COUNTY OF MIDDLESEX - INTERROGATORY #1

Filed: May 23, 2013
EB-2013-0040 and EB-2013-0041
Exhibit B
Tab 1
Schedule 3
Responses to County of
Middlesex Interrogatories
Appendix A

APPENDIX 'A'

Filed: May 23, 2013
EB-2013-0040 and EB-2013-0041
Exhibit B
Tab 1
Schedule 3
Responses to County of
Middlesex Interrogatories
Appendix B

PLS-CADD Drawing

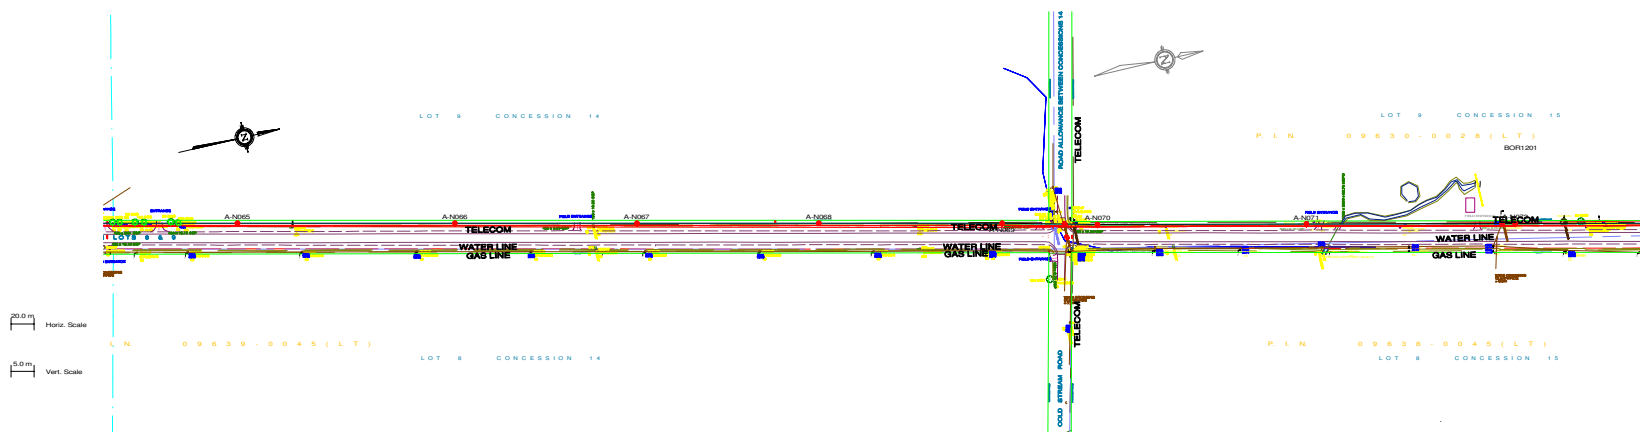
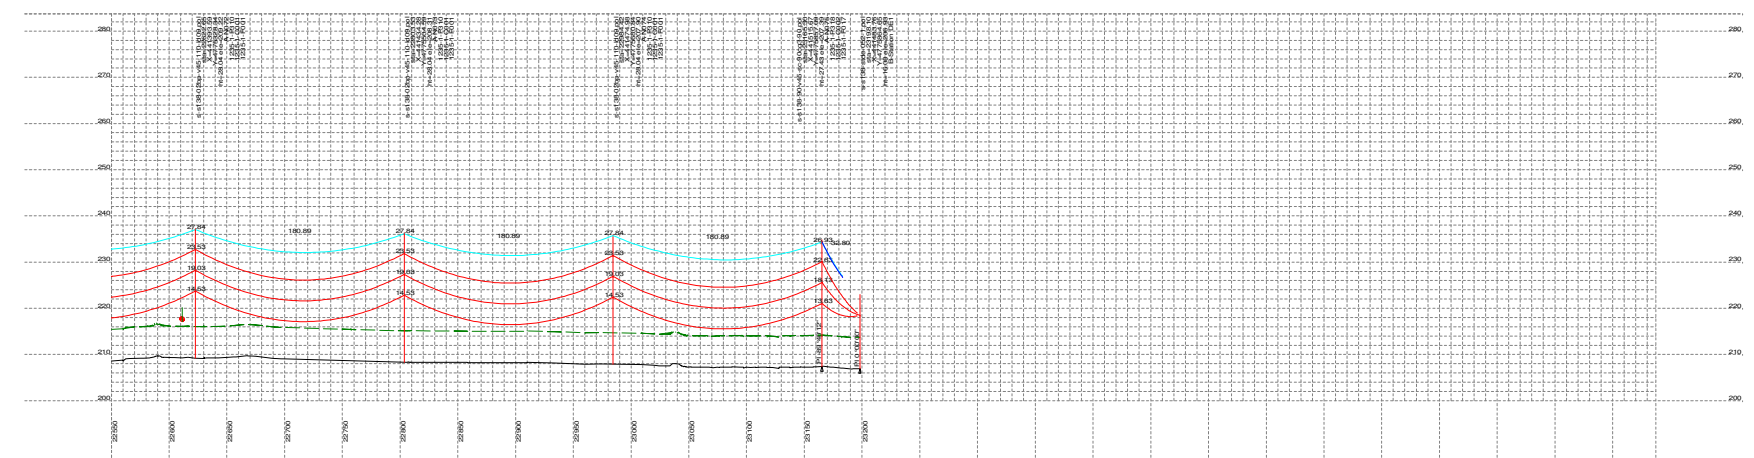
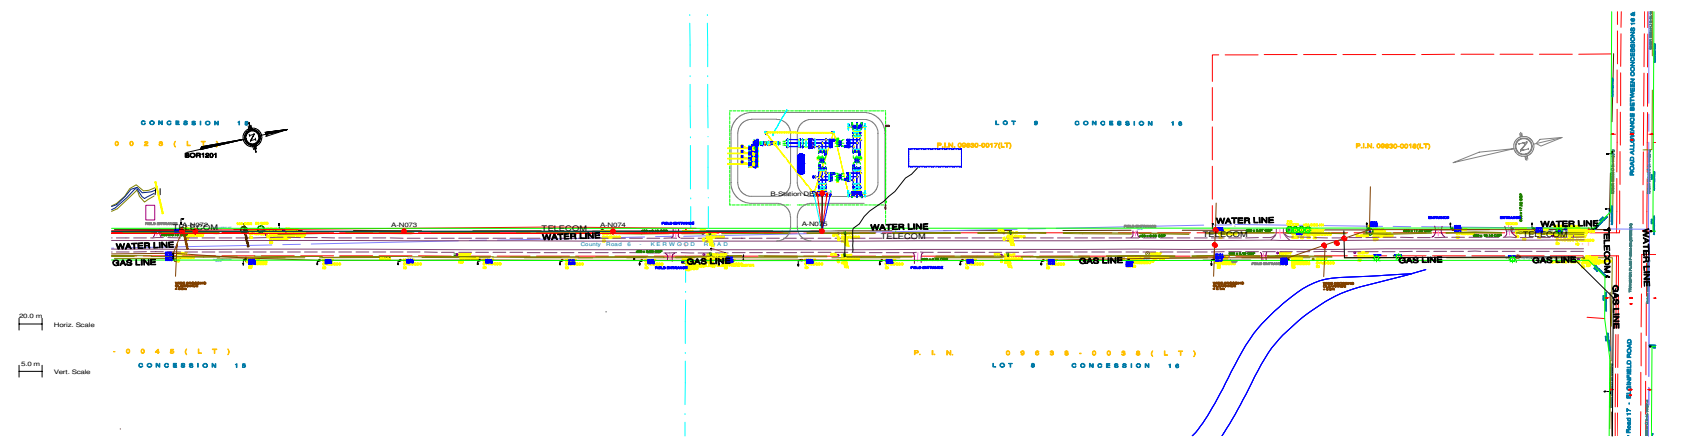
Please provide detailed engineering drawings showing the exact location of all poles and other appurtenances proposed to be located within County road allowances for transmission lines, including all material and construction specifications of poles, wires, guying, foundations, trenching, temporary conditions, and any other items related to this infrastructure.

Please see profile drawings in **Appendix 'A'** in respect of EB-2013-0040 and **Appendix 'B'** in respect of EB-2013-0041 depicting the current design, which is subject to final engineering. Earlier versions of these sets of drawings were provided to the County's Engineer on November 12, 2012. These drawings show the proposed pole, wire and anchor locations. Plans with respect to foundations, materials and construction specifications are not yet finalized. The physical design specifications for the proposed transmission line, including with respect to potential materials, are described in Exhibit D, Tab 1, Schedule 1. In addition, illustrations of potential pole structures and framing designs are provided in Figure 4 of Exhibit B, Tab 2, Schedule 5.
